Barron Resource Operations Plan Amendment 2011

Consultation Report

Prepared by: Water Allocation and Planning, Department of Environment and Resource Management

Figure 1: Water Allocation Zones

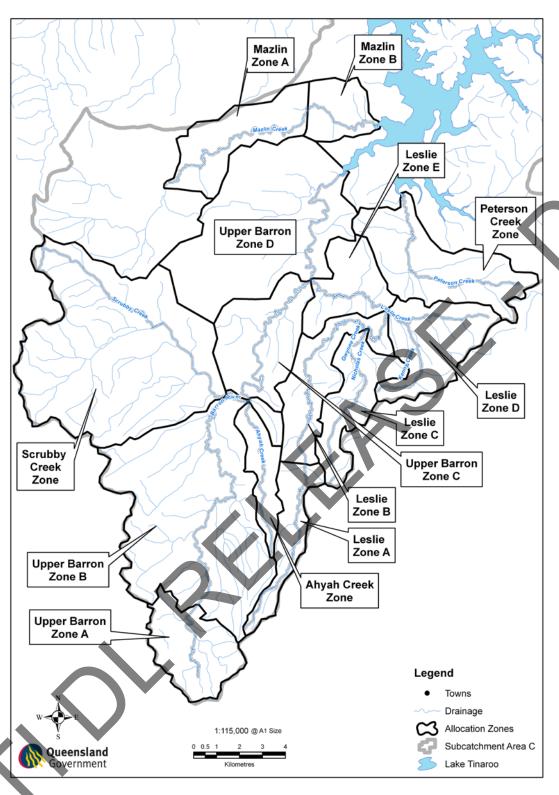
Within these catchment areas, the converting entitlements were to be grouped into 14 trading zones (Figure 1). The draft plan provided for permanent trading between zones that fell within a catchment area, subject to specified maximum and minimum volumes for each zone not being exceeded. Water taken under an allocation could be seasonally assigned, but only within the zone of origin.

A total of 51 submissions were received asking that seasonal assignments be allowed between zones under arrangements similar to those proposed for permanent trading. The submitters believed there would be greater demand for seasonal transfers because it would allow water users to explore the potential for trading to support their needs. Once the benefits of trading had been demonstrated and demand patterns established, permanent trading would be more likely to follow.

The final plan has been changed to allow seasonal assignment of water taken under allocations between zones within each of the subcatchment areas, subject to totals remaining within the band specified by minimum and maximum volumes for each zone.

Figure 2. Flow duration curves

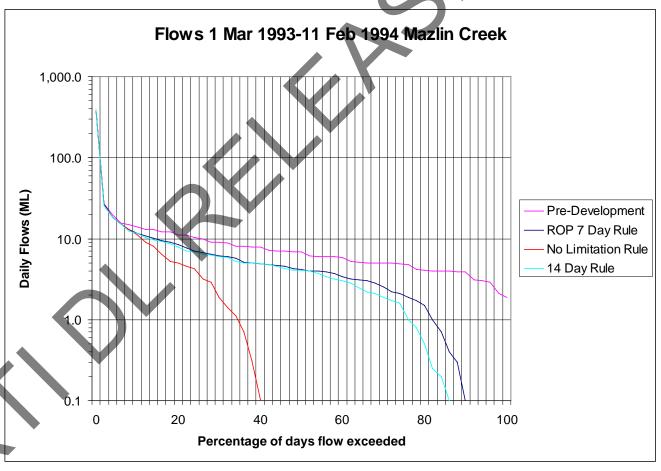
In 51 submissions it was argued that the restrictions should be introduced only when flows remained below thresholds for 14 consecutive days, and that they should be withdrawn when flows stayed above the respective rising flow thresholds for only seven days.

It was also argued that the 21-day periods specified for lifting the restrictions were excessive. Some of the trigger thresholds were seen as too high and the submitters called for the thresholds to be lowered to reduce the occurrence of the restrictions being introduced.

The results of the comparative assessment of flows in Mazlin Creek during the 1993–94 dry season are shown below in Figure 2. It can be seen that at higher flows, there is little difference between the scenarios, because demand for irrigation water at these times is comparatively low, resulting in little effect being evident on the predevelopment case. Of particular note, is the presence of flows above one ML/day for 100 per cent of days under the predevelopment case.

However, as diminishing flows approach 10 ML/day and demand increases, the scenarios begin to diverge, with the most pronounced effects evident under the 'no rules' case, which shows a dramatic increase of about 60 per cent in the occurrence of no flows—that is flows of less than one ML/day.

Divergence between the proposed alternative rule and the draft plan provisions becomes increasingly evident as flows approach the critical one ML/day where a 6 percentage increase in the number of very low flow days. Although the difference might appear relatively small, during the dry season stage of the water cycle, the presence of additional water in the system under the draft plan rules is regarded as environmentally significant, whereas the proposed alternative and would compromise the water resource plan's environmental flow objectives.

The issue was reviewed by an independent referral panel, which recommended that the draft plan provisions remain unchanged.

The final plan's rules for initiating and withdrawing restrictions in the priority area upstream of Tinaroo Falls Dam are unchanged and are consistent with the water resource plan's environmental flow objectives. This approach best reflects the dynamic nature and seasonality of watercourses in the Upper Barron and would not result in excessively frequent activation of restrictions that would present management difficulties for water users. The 21 day period for withdrawing restrictions is considered appropriate because of the importance of allowing flows to recover following the dry season.

Figure 3. Zones for Atherton Subartesian Management Area A

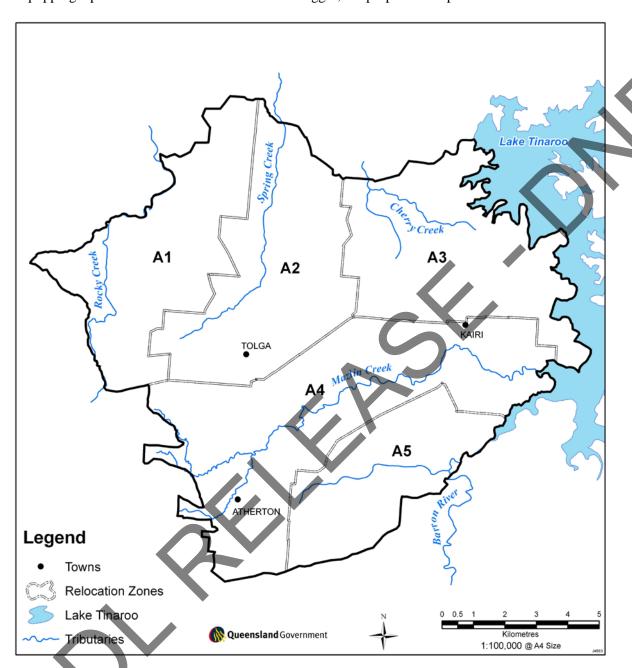
Several submitters disputed the validity of the delineation of the zones proposed for management area A, arguing that they should instead have been based on the surface water catchment boundaries for the areas. A single submitter with property in two zones believed the zones should be amalgamated.

The relocation zones for management area A have been redrawn to approximate the surface water catchments and are shown in Figure 3. The provisions for groundwater trading remain unchanged in recognition of the benefits that water trading will bring for groundwater users on the Atherton Tablelands.
